Joint Committee on Infrastructure & Police Commission

Meeting of August 13, 2025

Nashua Police Department Renovations & Additions 9 Riverside Street Nashua, NH

August 13, 2025

**Request For Information**

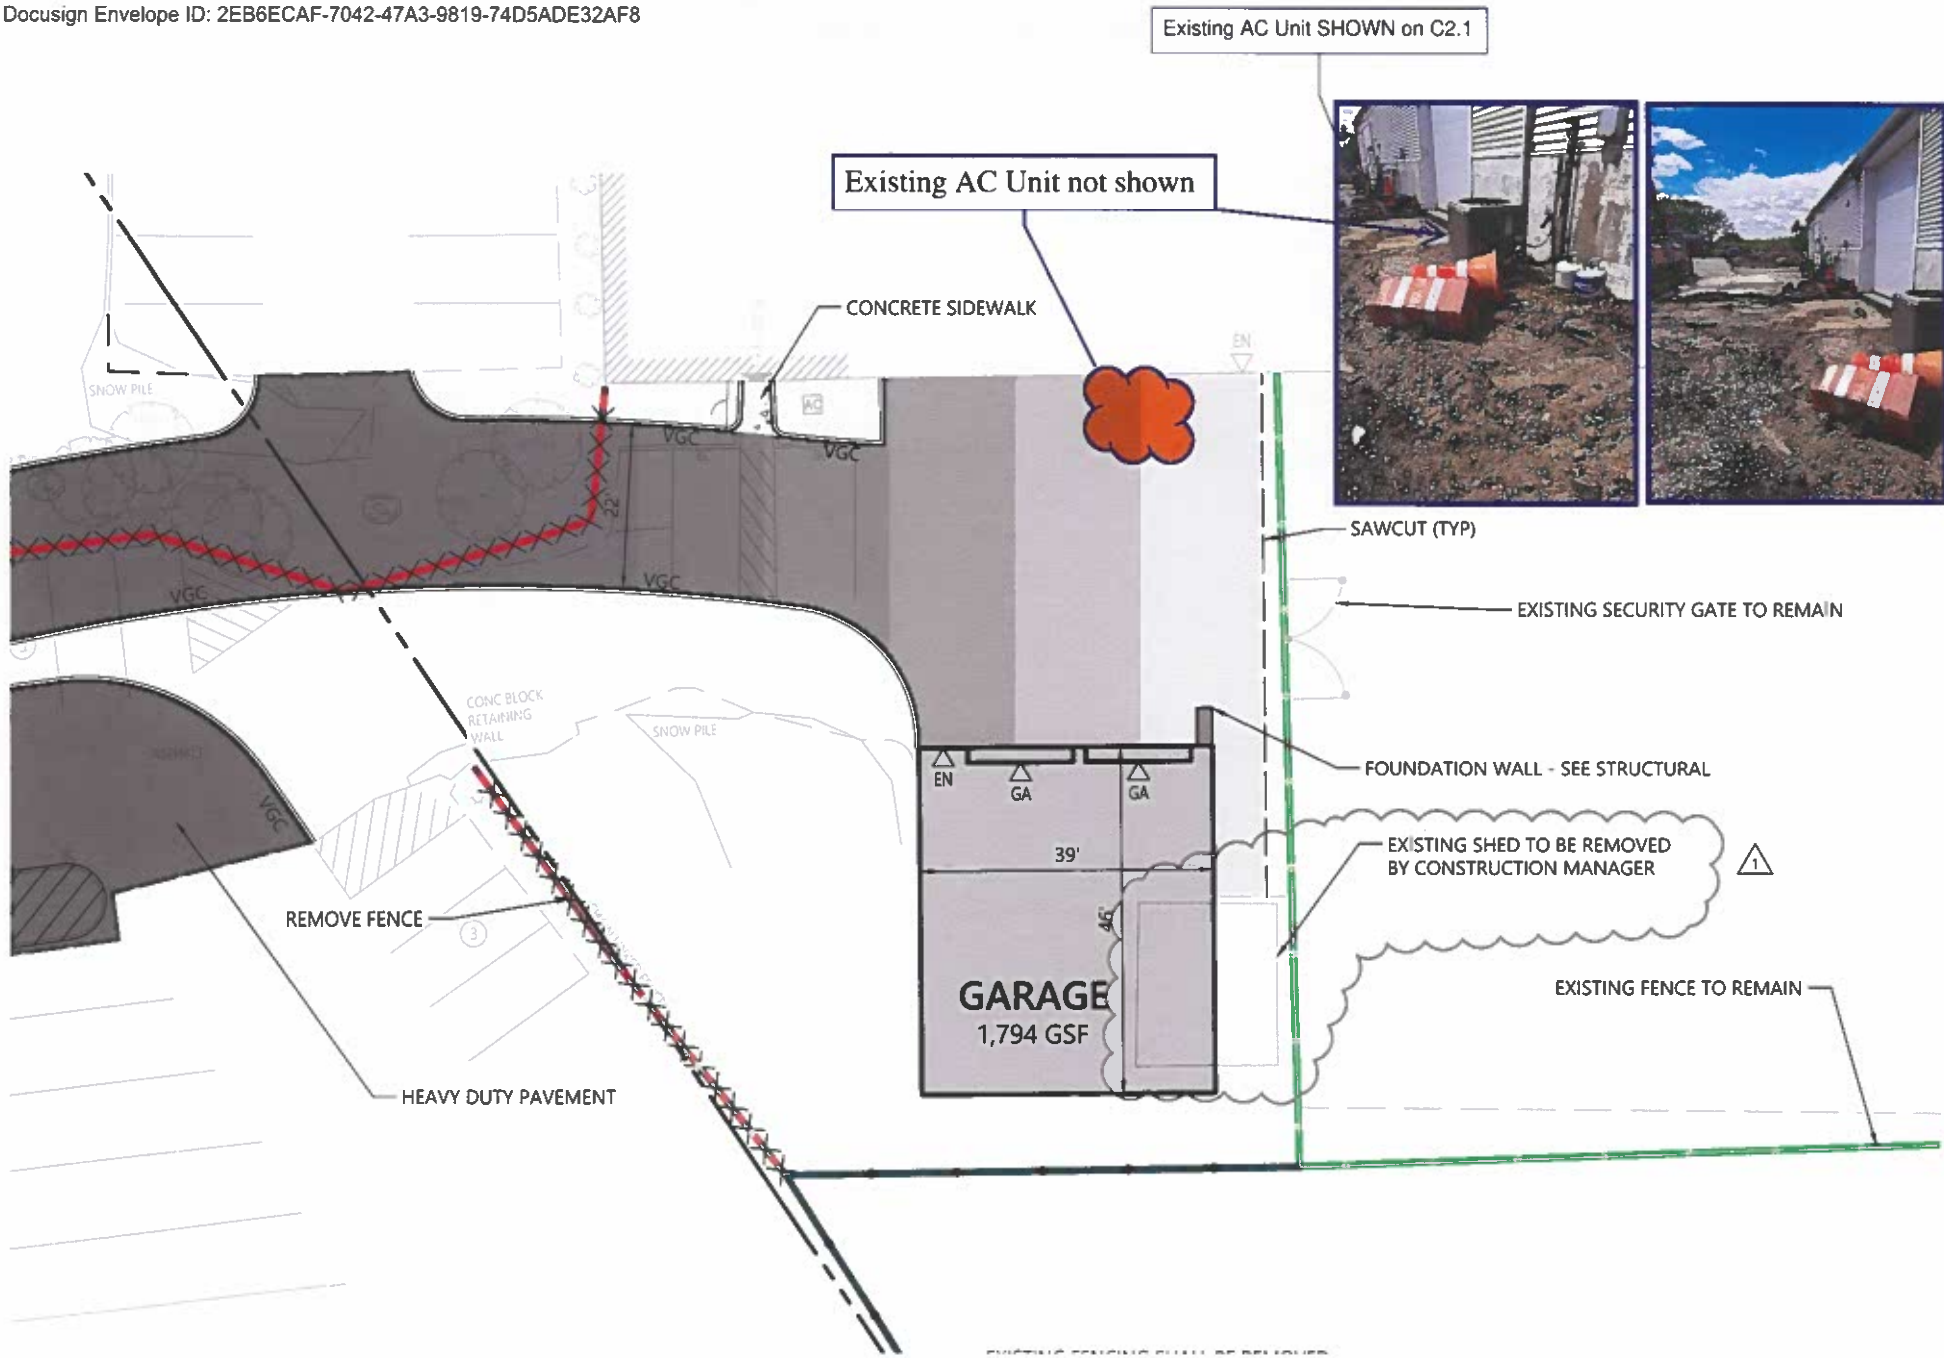
LBA and VHB have reviewed this condition. It was unfortunate that an RFI wasn't raised to clarify action at this location since there was no work in mechanical drawings to remove the compressor unit. And, it was missed on the Civil construction documents.

Question	Date Required: 05/23/2025								
C2.1 shows 1 existing AC condenser at the entrance to the SWAT facility with the new Heavy Duty Pavement being installed right up to the SWAT garage door/edge of building. However, there is an additional AC condenser located where Heavy Duty Pavement is shown to be installed. Please advise how to proceed.									
Suggestion									
<table style="width: 100%;"> <tr> <td style="width: 25%;">Cost Impact</td> <td style="width: 25%;">Cost Amount</td> <td style="width: 25%;">Schedule Impact</td> <td style="width: 25%;">Days</td> </tr> <tr> <td style="text-align: center;">YES</td> <td></td> <td style="text-align: center;">No</td> <td></td> </tr> </table>	Cost Impact	Cost Amount	Schedule Impact	Days	YES		No		
Cost Impact	Cost Amount	Schedule Impact	Days						
YES		No							
No Suggestion Provided									
Notes

SCOPE OF WORK: The Contract Documents showed 1 existing AC Condenser at the entrance to the SWAT facility with VGC being installed around it and new heavy-duty pavement being installed up to the building. However there is an additional AC condenser at this location and thus the heavy-duty pavement cannot be installed as shown. RFI #027 was submitted and returned instructing to install new curb around the 2nd AC Condenser and to provide cost options for the City to review and select. Cost options for VGC and Cape Cod Berm were presented, and the NPD's selection was to match the other curb and install VGC.

Costs for this change are for labor, materials and equipment to install 23' of additional VGC around the 2nd AC Condenser. All work to be performed in accordance with the contract documents.

SI-02 REV; DATA ROOM LIGHTING & CONTROLS

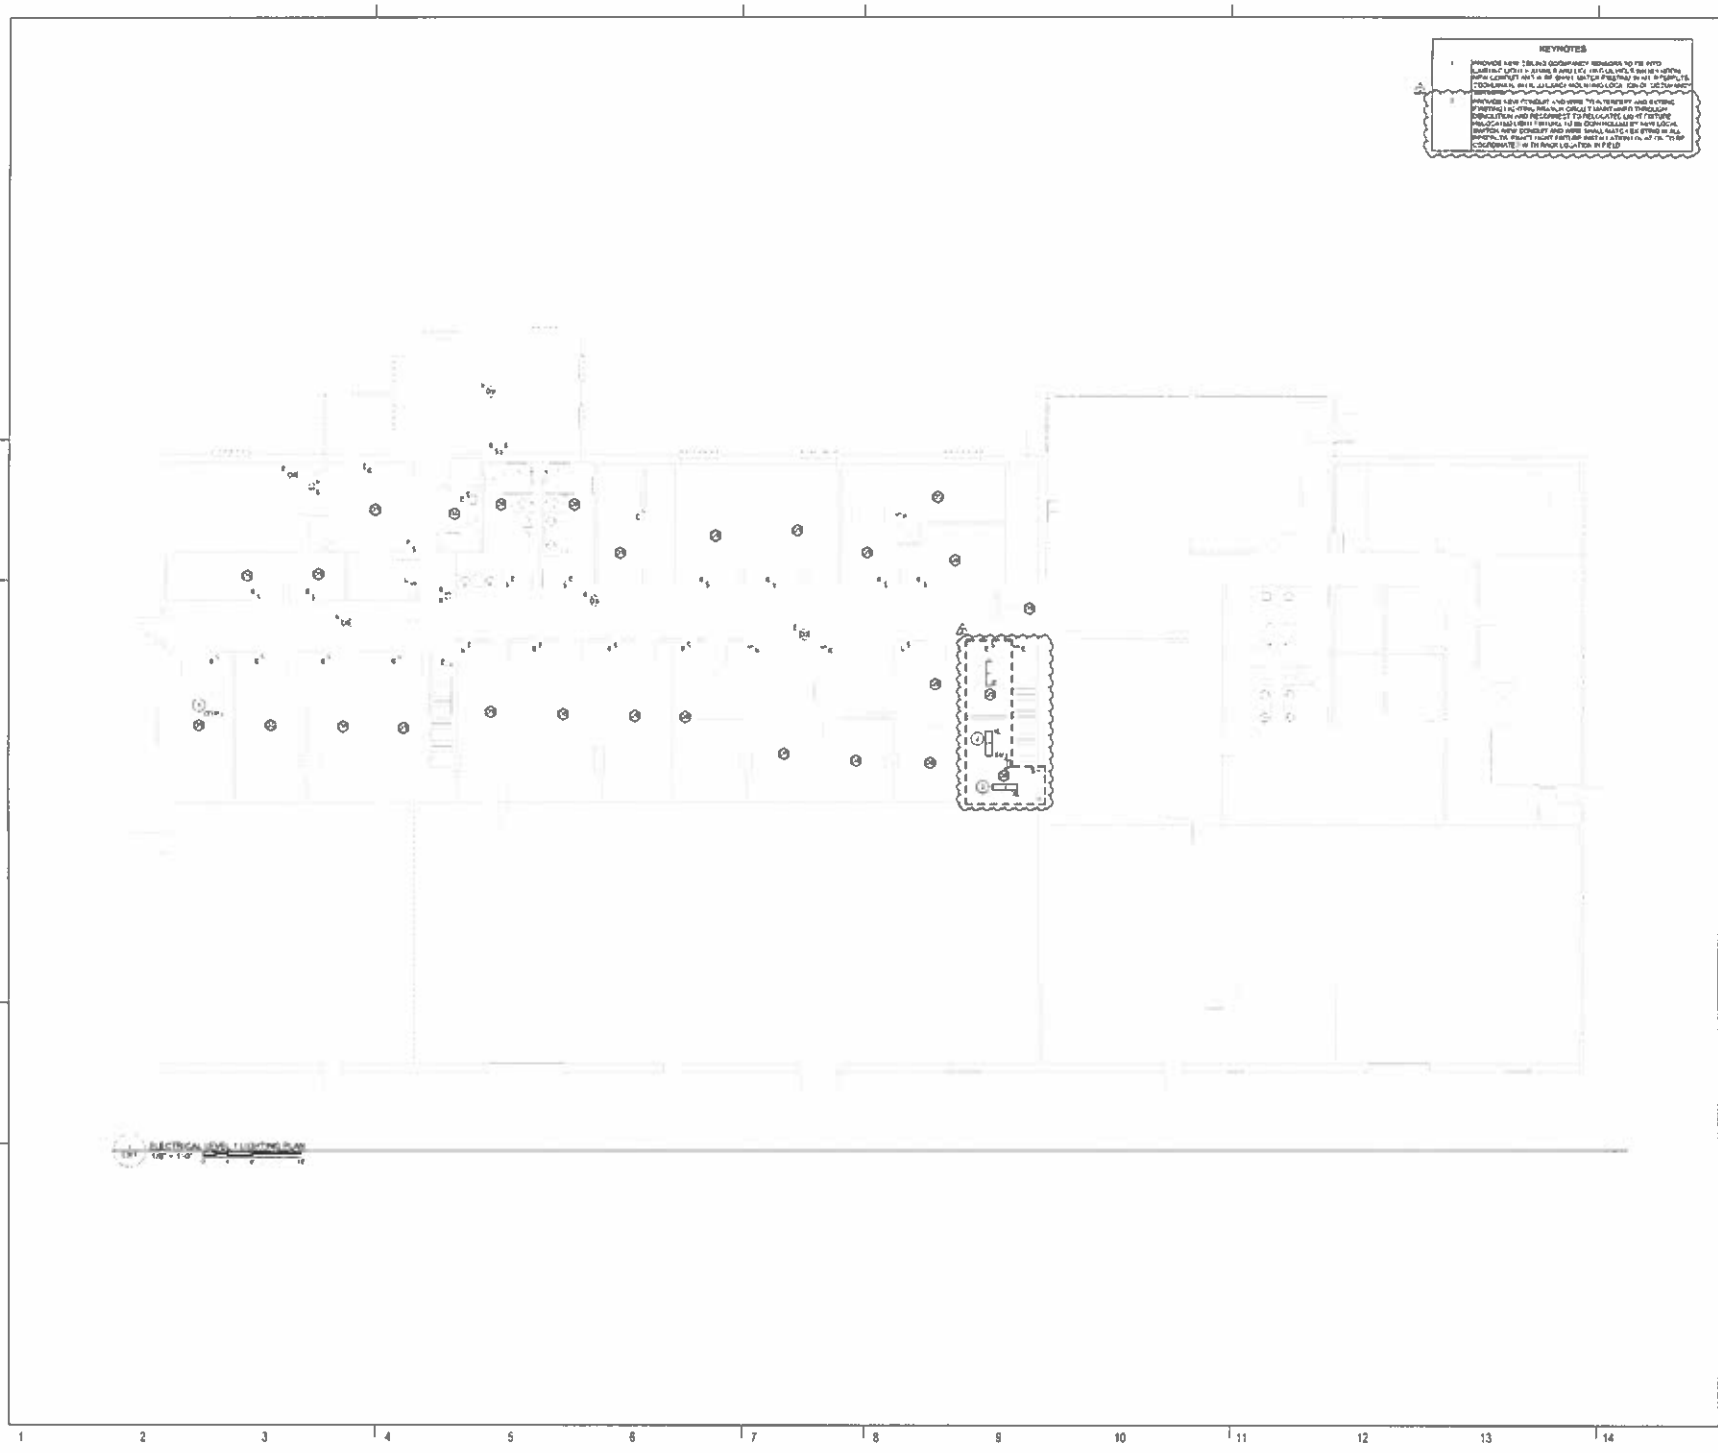
Please find attached UPDATED drawings COORDINATING WITH LATER RELEASED RFI RESPONSES identifying the resolution of a conflicting existing light fixture and the reconfiguring of lighting and controls for the new Data Room (NTS).

Please note the inclusion of a new upgraded quality light fixture to replace the removed fixture as requested by the City.

Costs for this change are to labor and materials to furnish and install the added EM-1 light fixture. All work to be performed in accordance with SI-02.

RFI #025 Added Handhole for Remove Light Pole

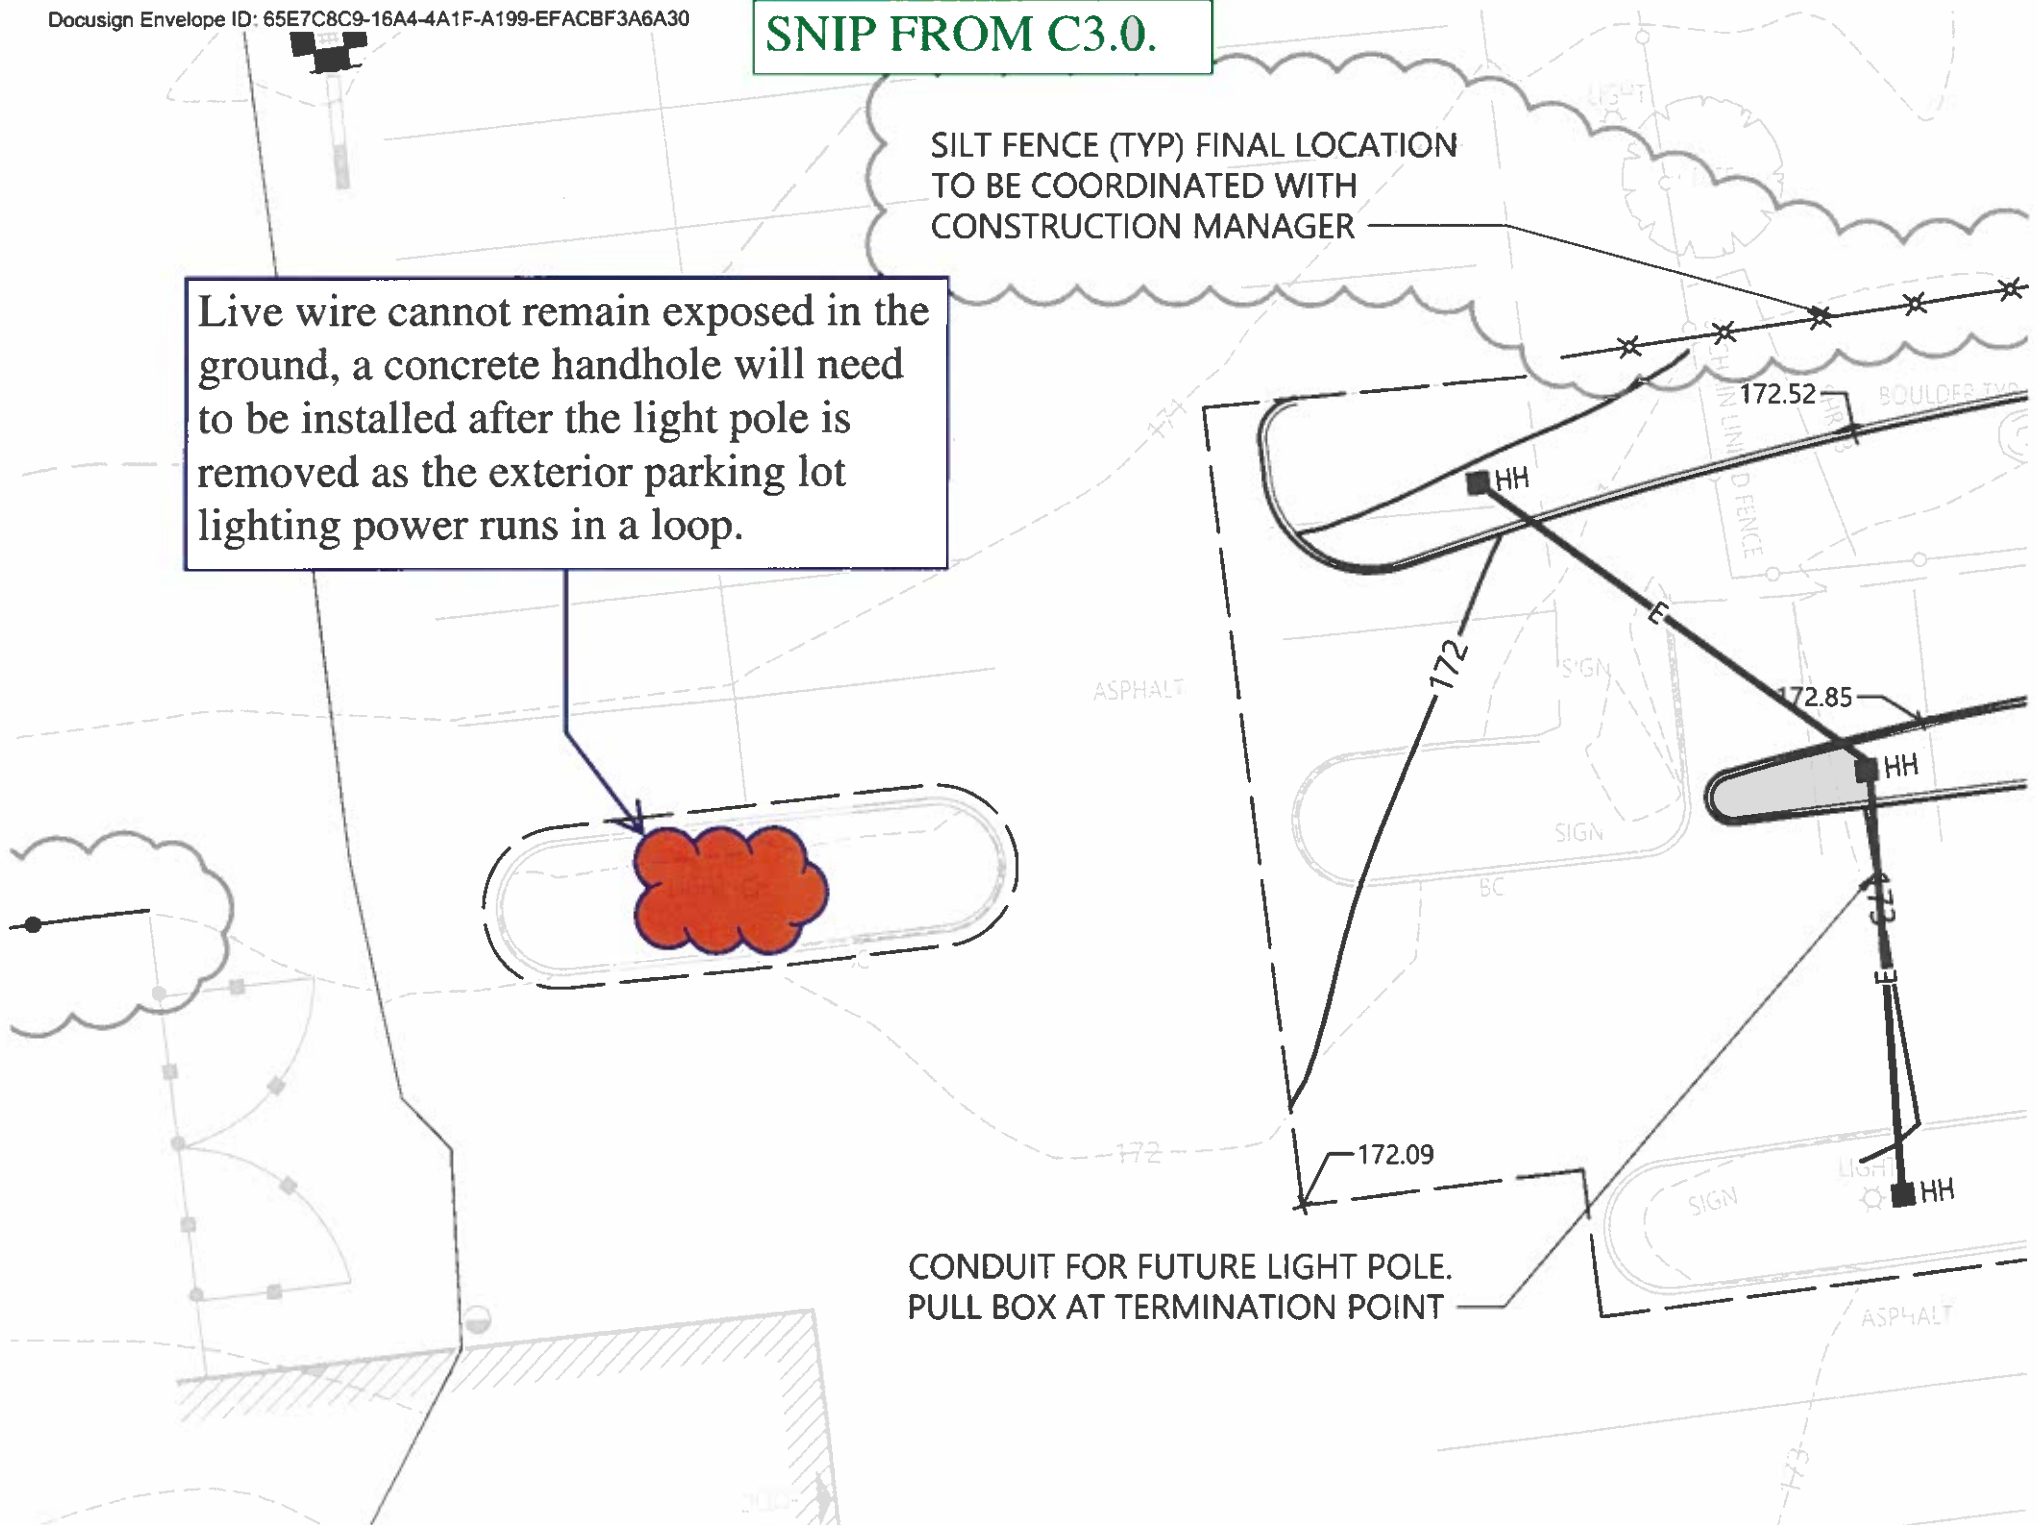
At the plan west island and light pole that is called to be removed, a handhole is required as live wire cannot be left exposed in the ground. The wire must remain live because the light poles in the PD parking lot are all on 1 loop, thus disconnecting the 1 would be disconnecting them all. As a result, a concrete handhole needs to be installed at this location. Please confirm installing a concrete handhole at the location shown in the attached sketch is acceptable.

Live wire cannot remain exposed in the ground, a concrete handhole will need to be installed after the light pole is removed as the exterior parking lot lighting power runs in a loop.

Costs for this change are for electrical labor and materials to install 1 concrete handhole and make all final connections at the plan west island in accordance with the response to RFI #025.

- Minimum requirements shall be that all sections of the product shall be designed for HS-20 loading.
- Submit a shop drawing for a product for review.
